11 June 1956

MEMORANDUM FOR: THE RECORD

SUBJECT : Project Monitors at [redacted]
RD-61sa, Tasks I - IV

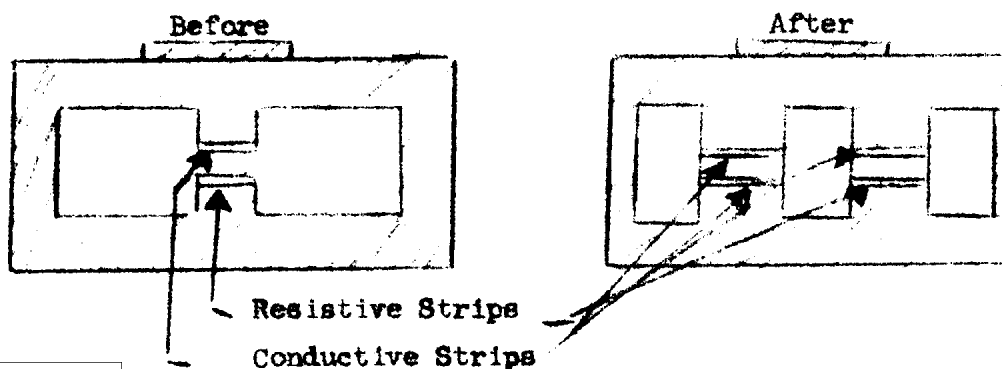
Since an average operating time of 4 hours per day is believed to be reasonable, it is apparent that a switching system allowing the monitor to be completely shut off when the [] is not in use will save a factor of 1/6 in battery size. To make this saving possible, [] has been requested to try the following modification in the transducer.

[] will report by 30 June the feasibility of this change. The basic decoder work at [] will be continued after the transducer modification. A thorough investigation of commercially available [] will be made. If possible, a complete [] decoder will be built although the present contract does not require it due to an extension of scope without increase of funds.
